REMARKS

AMENDMENTS TO THE DRAWINGS:

FIG. 5

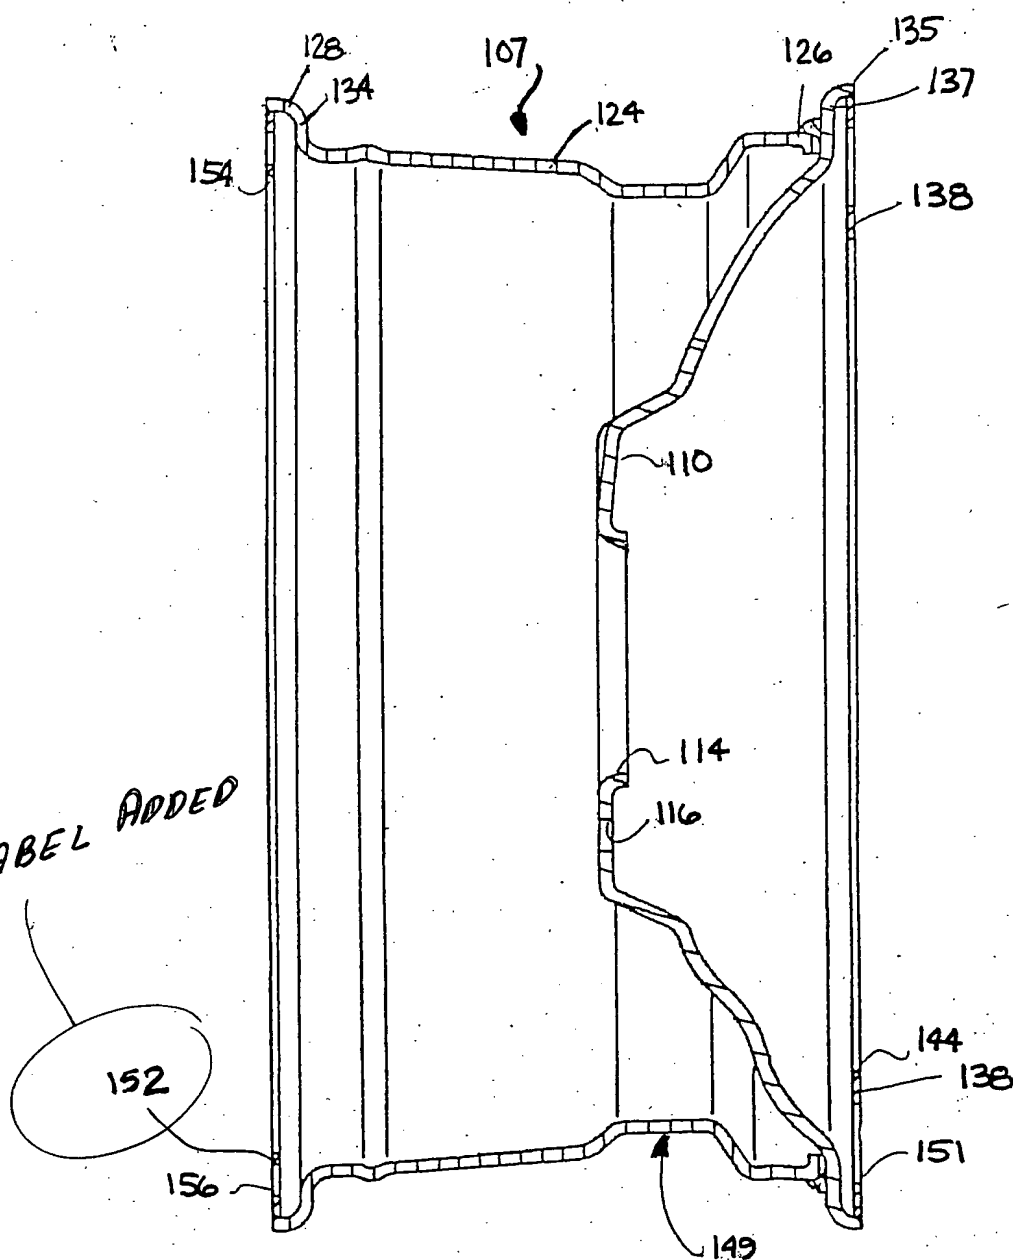
In the Office Action, the drawings stand objected to for not including reference character 152, found in the specification.

In the Office Action, the specification stands objected to since reference character 154 in Fig. 5 is allegedly not described in the specification.

LABEL ADDED

With regard to the drawings, Applicant hereby proposes labeling Fig. 5 to include the reference character 152 for the inboard reinforcing ring. Accordingly, Applicant respectfully requests withdrawal of the objection to the drawings.

With regard to reference character 154 (i.e. inner diameter 154), Applicant respectfully directs the Examiner's attention to original paragraph [0019] which states:

“The wheel arrangement 107 also has an inboard reinforcing ring 152 which has an outer diameter which is continuously weldably connected to the inboard tire bead seat 134. The inboard reinforcing ring 152 has an inner diameter 154 which is greater than the minimum diameter 149 of the drum and which is significantly greater than the inner diameter 144 of the outboard reinforcing ring. The inboard reinforcing ring 152 has a radial width which is significantly smaller than the radial length of the outboard reinforcing ring 138. In a manner as previously described the outboard reinforcing ring has a series of apertures 156 which allow for the removal of moisture.”

The attached drawing sheets include changes to Fig. 5, wherein Fig. 5 has been labeled to include the reference character 152 for the inboard reinforcing ring.
